Fargo VAMC – Refurbish Elevators and Replace Controls

Fargo, North Dakota
Project #19-2481

MARCH 26, 2024

ADDENDUM NO. 2

3 FLOOR PLAN - ELEVATOR 12 - PIT
1/4" = 1'-0"

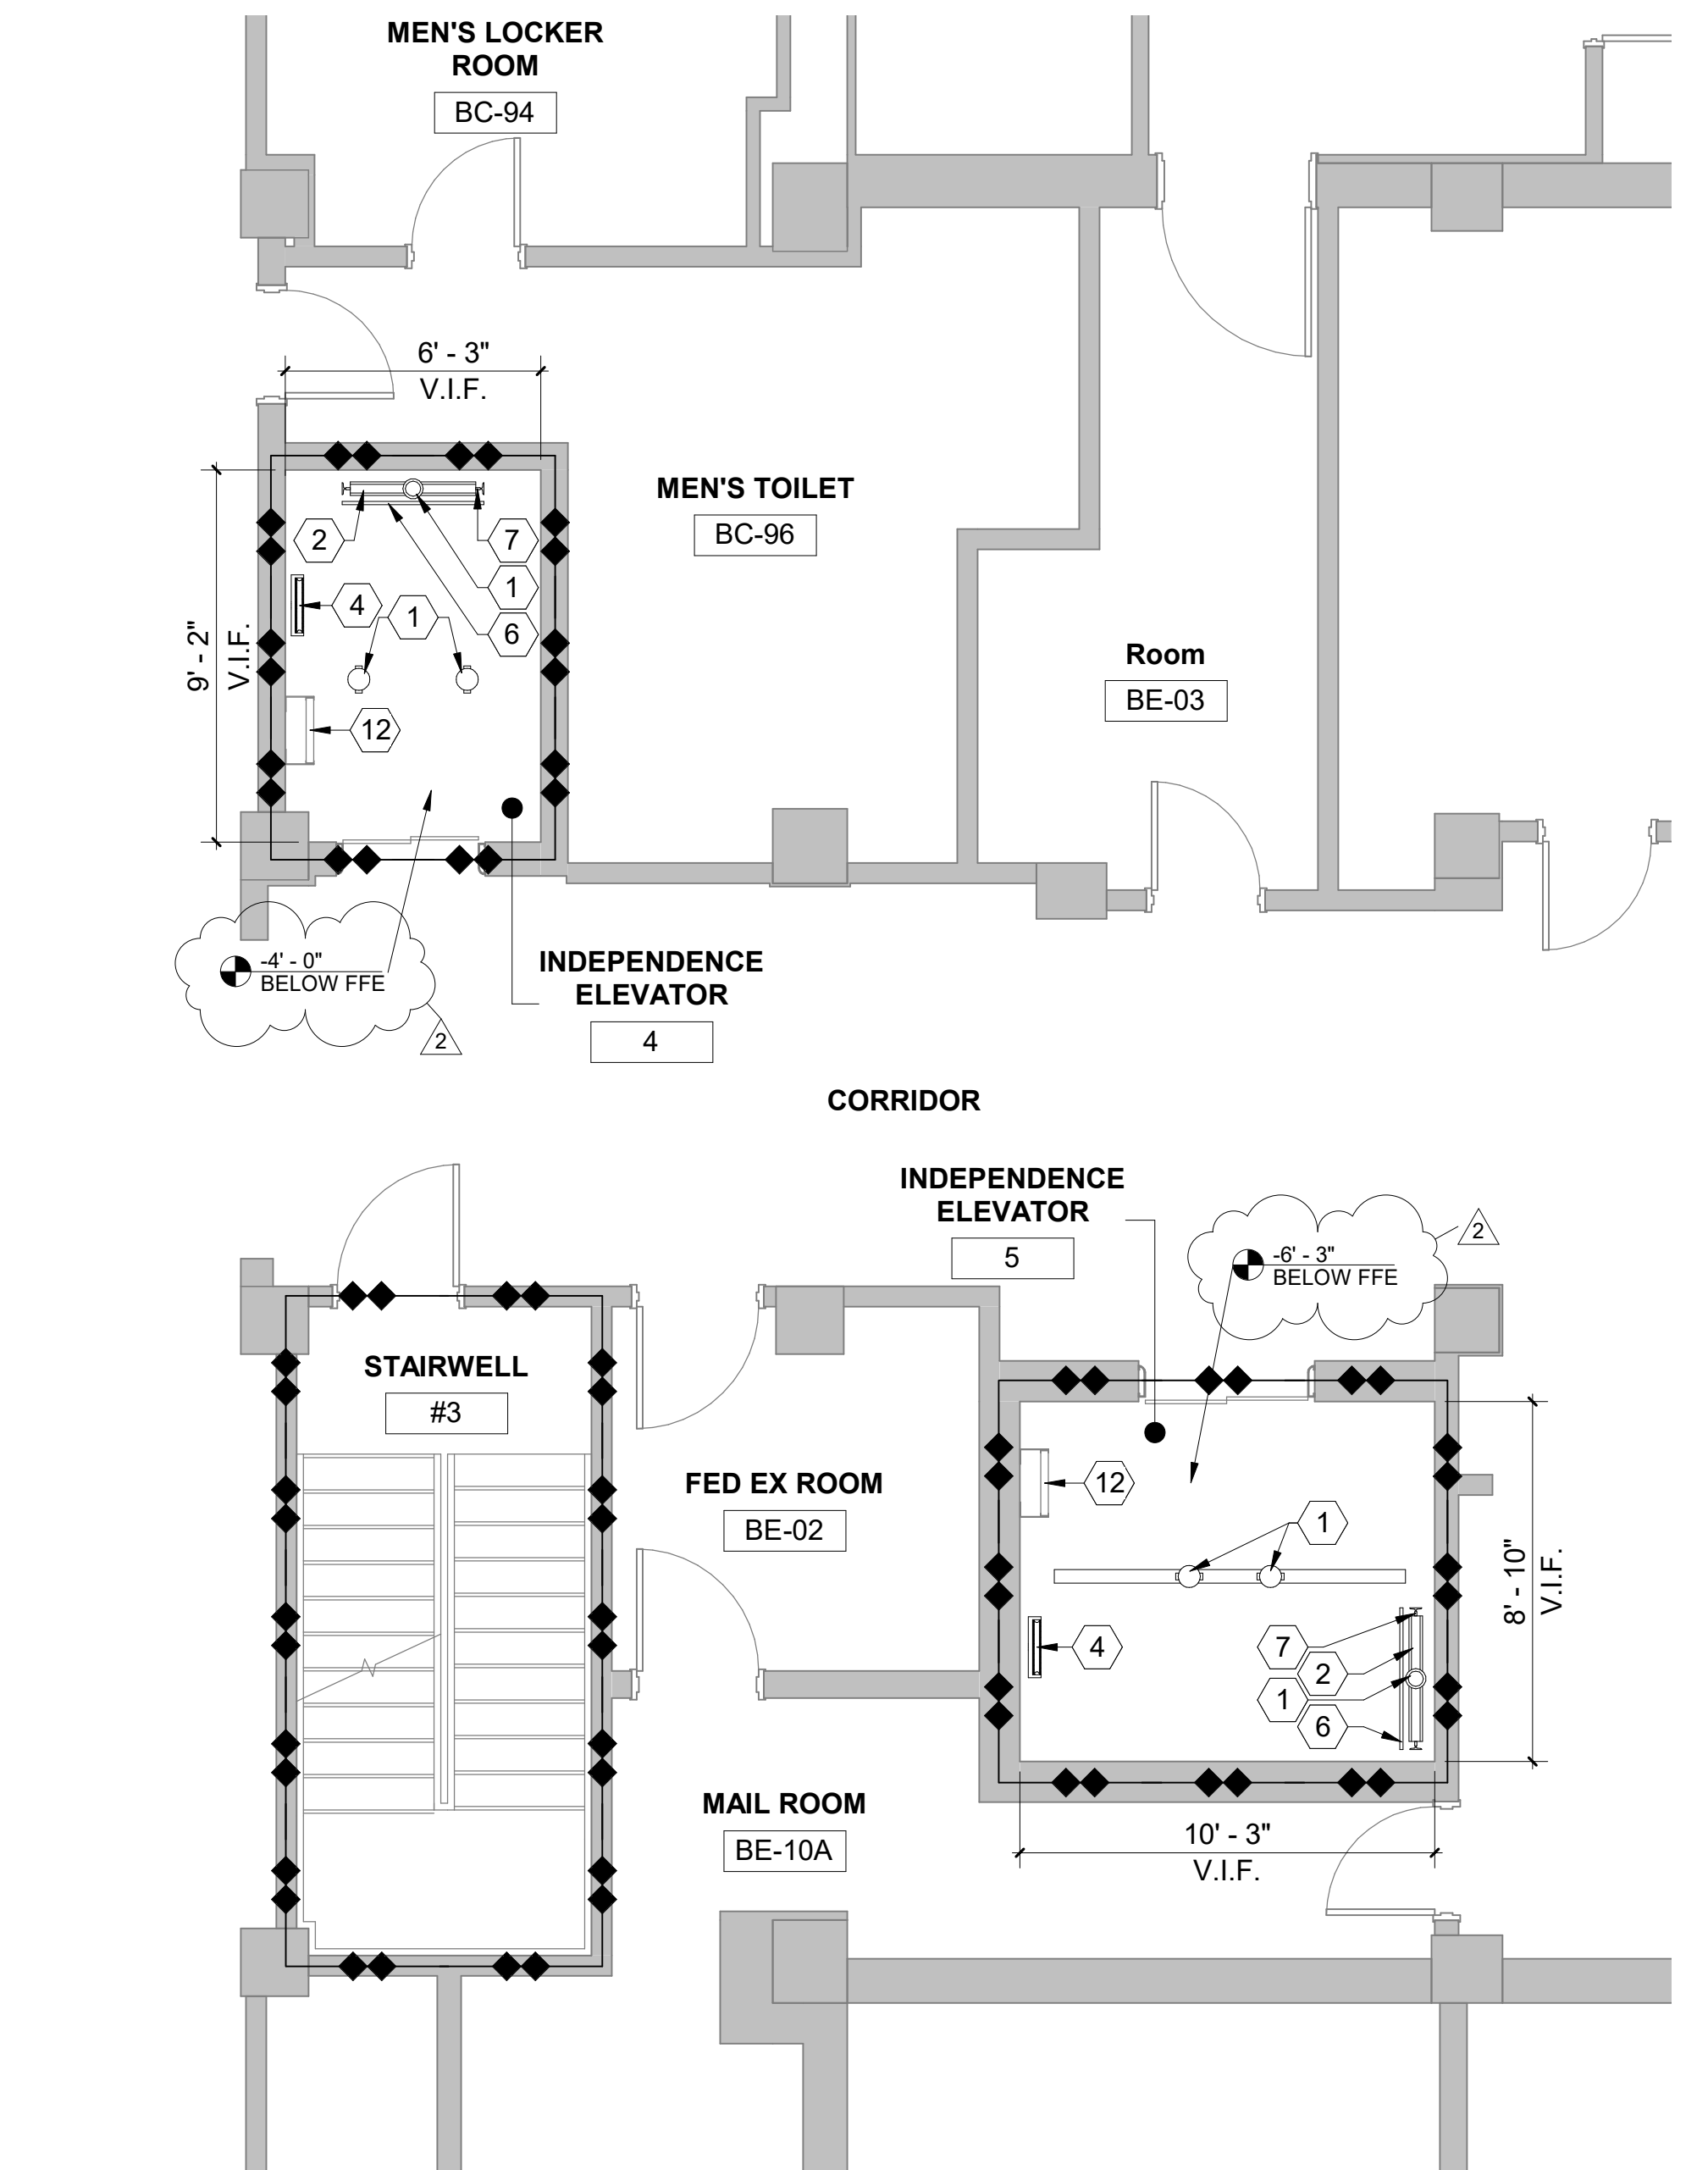
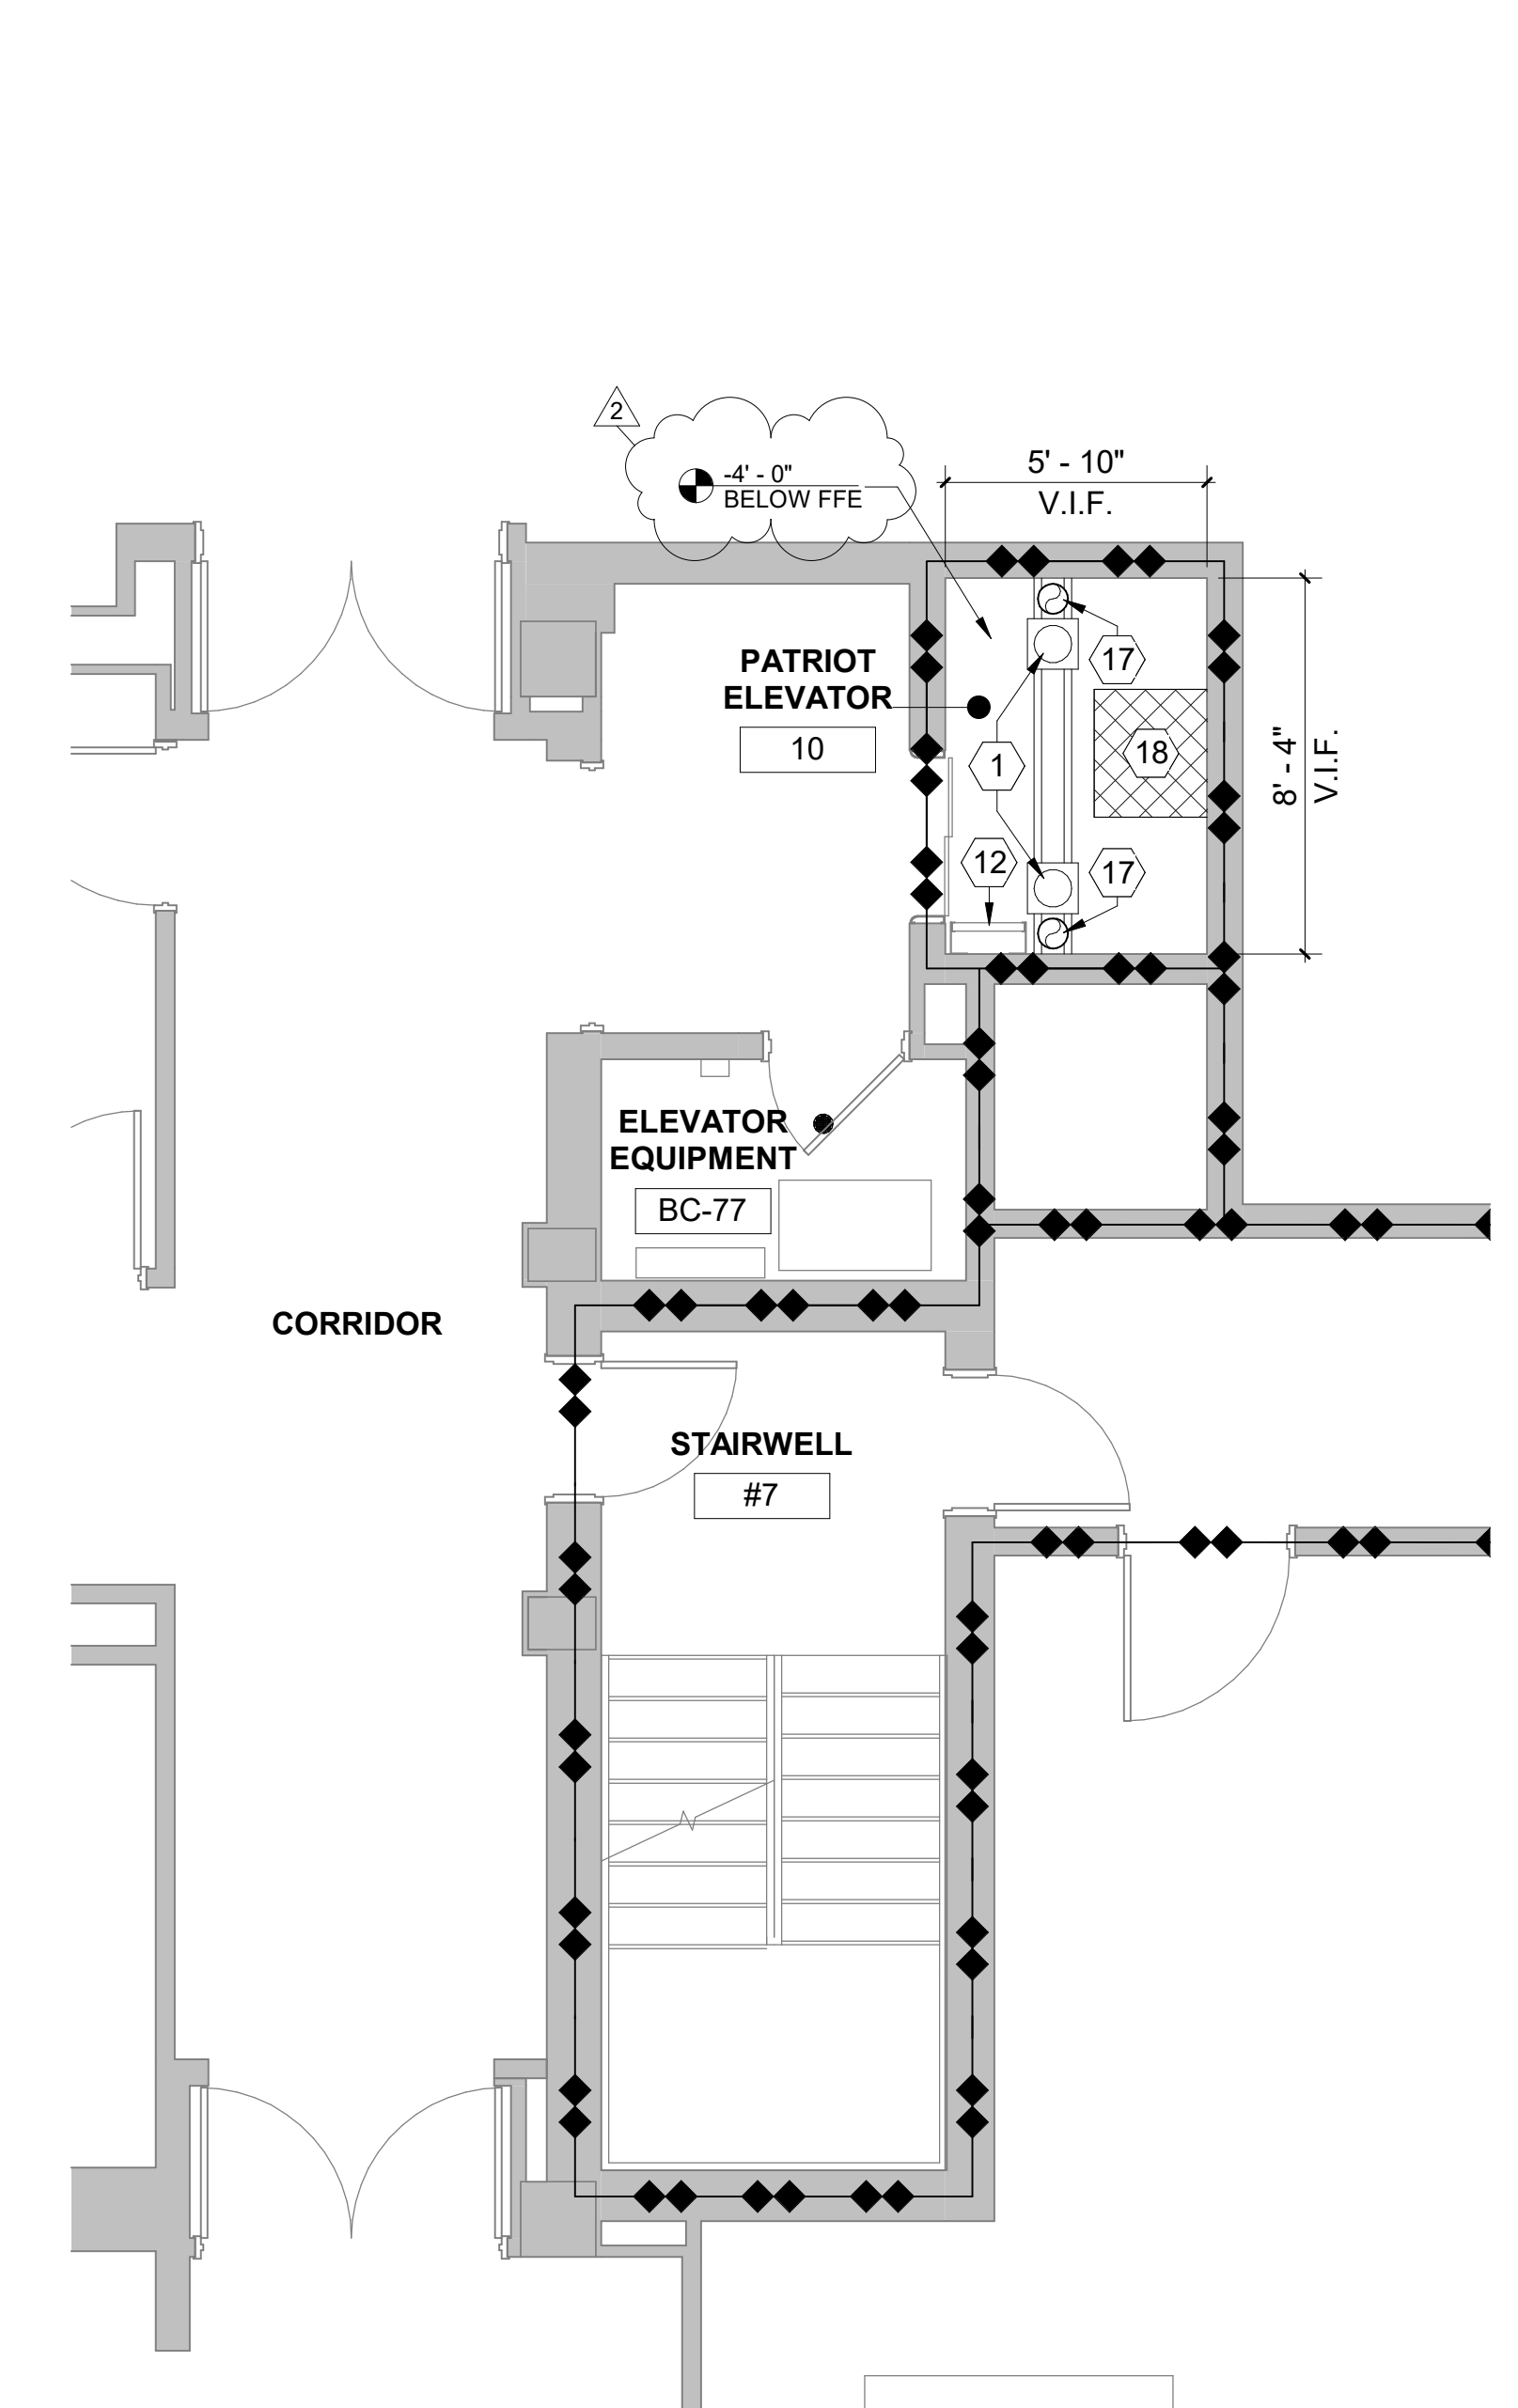
Drawing Sheet A5.20 ENLARGED PLANS – ELEVATOR PITS – See revised drawing sheet for the adjustment of keynotes # 3, 9, 15, 16, 17. Also included is the depth of each elevator pit relative to the floor elevation at the lowest elevator lobby for each hoistway.

11. RESILIENT TILE FLOORING. SEE SPECIFICATIONS.
12. NEW LOWER SECTION OF GUIDE RAILS (APPROX 20 LF AT EACH RAIL. INSTALL TO COORDINATE WITH OTHER NEW EQUIPMENT. PROVIDE NEW MOUNTING BRACKETS. APPLIES TO ELEVATOR 7 AND 8 ONLY DUE TO WATER DAMAGE.

13. NEW LOWER SECTION OF COUNTERWEIGHT RAILS (APPROX 20 LF AT EACH RAIL AND PIT GUARD. INSTALL TO COORDINATE WITH OTHER NEW EQUIPMENT. PROVIDE NEW MOUNTING BRACKETS. APPLIES TO ELEVATOR 7 AND 8 ONLY DUE TO WATER DAMAGE. EXISTING HYDRAULIC PISTON JACK TO BE REUSED. REPACK ENTIRE ASSEMBLY.
